DEPARTMENT OF CONSUMER AND REGULATORY AFFAIRS
OFFICE OF THE ZONING ADMINISTRATOR

September 25, 2019

RE: 3101 Woodland Drive, NW and 2700 31st Street, NW
Lots 0001 & 0015, Square 2126, Mass. Ave. Heights
Zoning Confirmation (19-Z-PDRM-00182)

EXISTING CONDITIONS PLAN

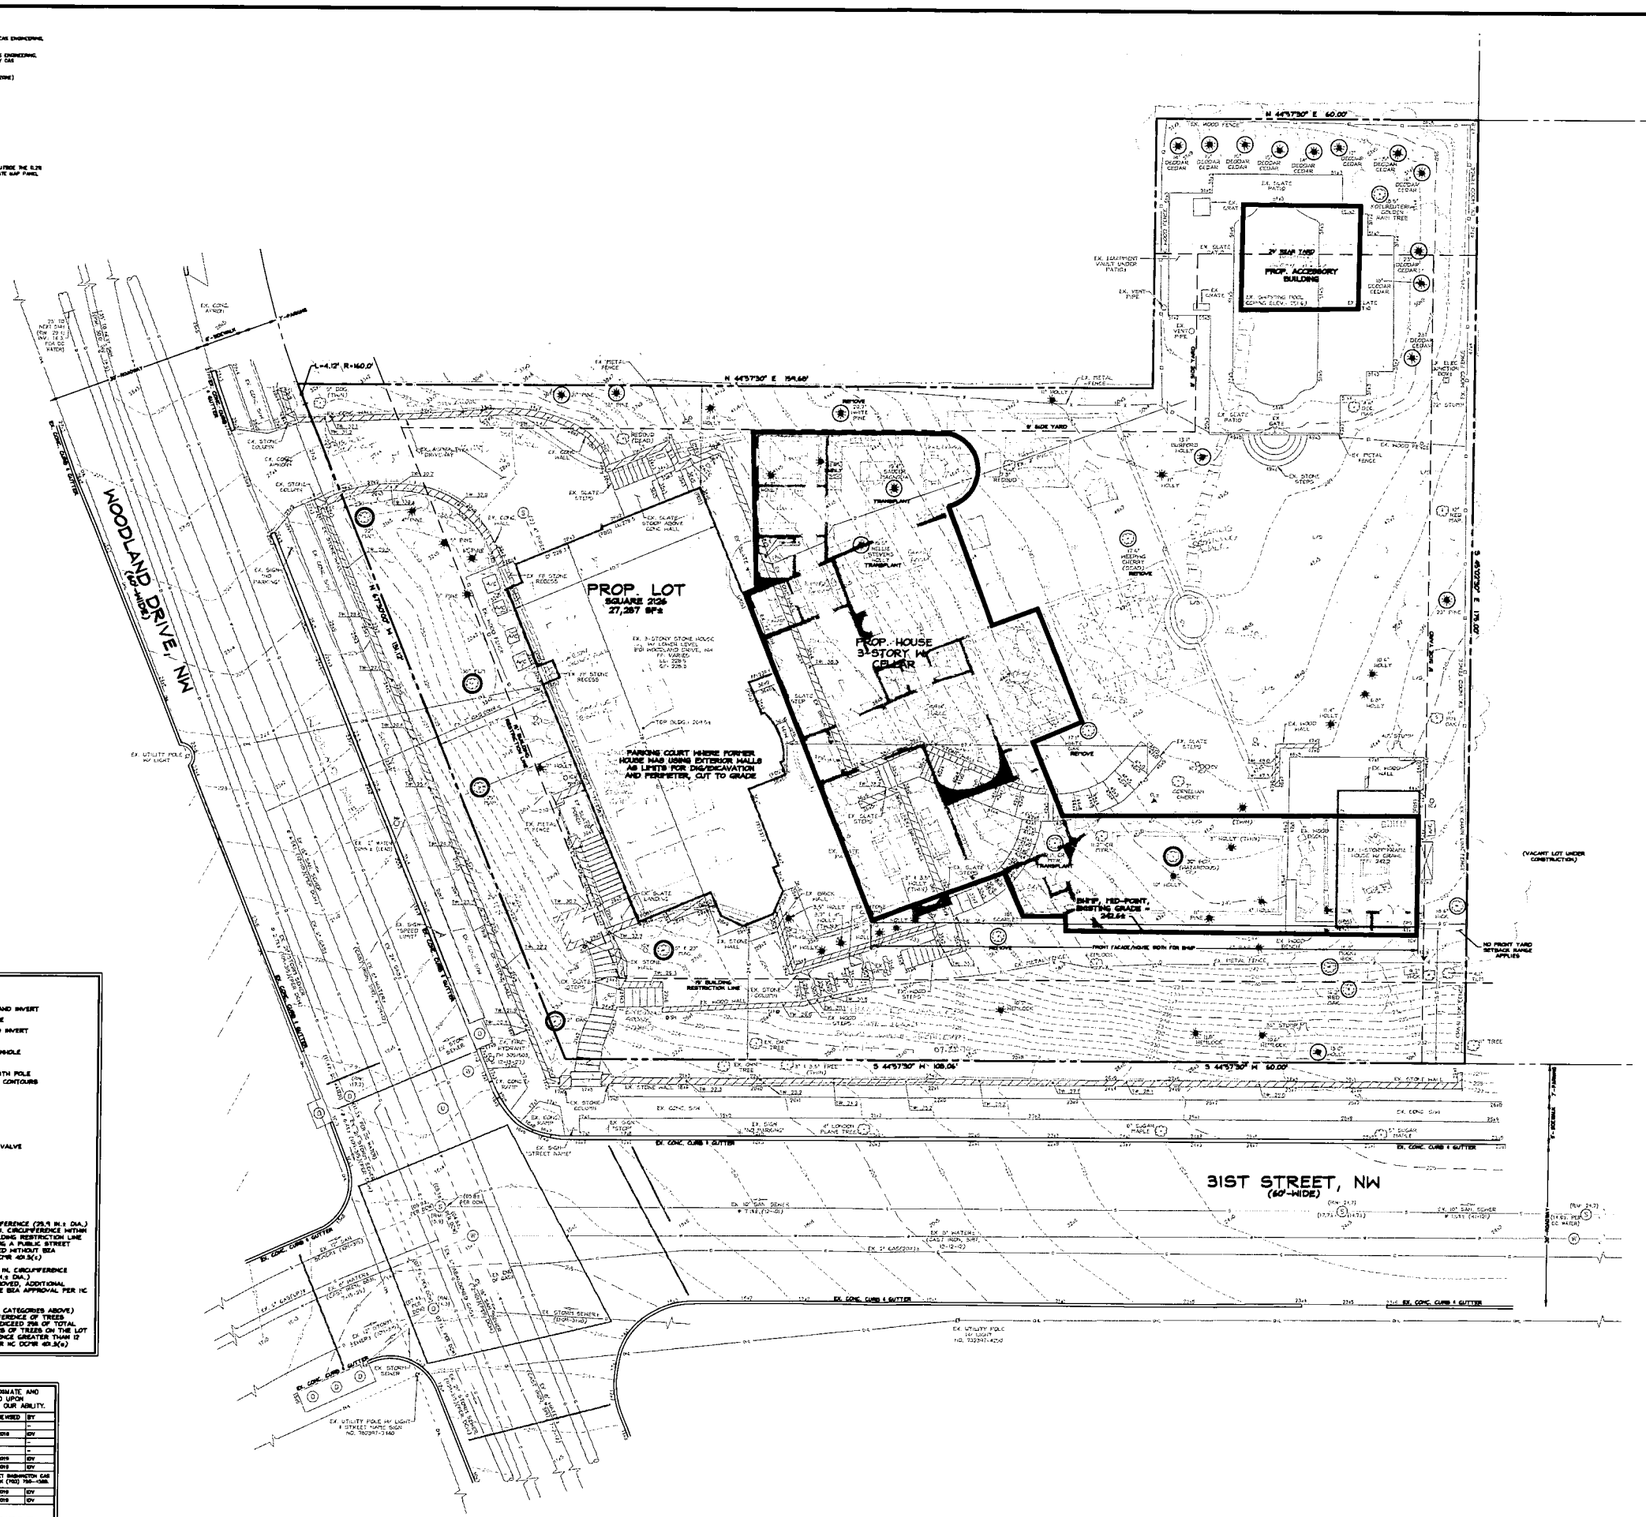
Allowed Lot Occupancy = 30%, includes house, elevated terraces attached to the main building, covered stoops/porches and structures >4' above adjacent grade. The proposed lot occupancy on the Conceptual Site Plan is 21.5% and meets this requirement.

25 feet required and provided for main building as shown from the furthest property line generally parallel to the front lot line as prescribed under 11-B DCMR 318. I concur that the rear yard as show is applicable to this project.

I have reviewed the concept plan as proposed and concur that the development of a new single-family detached dwelling as shown/proposed meets the requirements of 11 DCMR, specifically the sections of 11-B, 11-C and 11-D DCMR noted above).
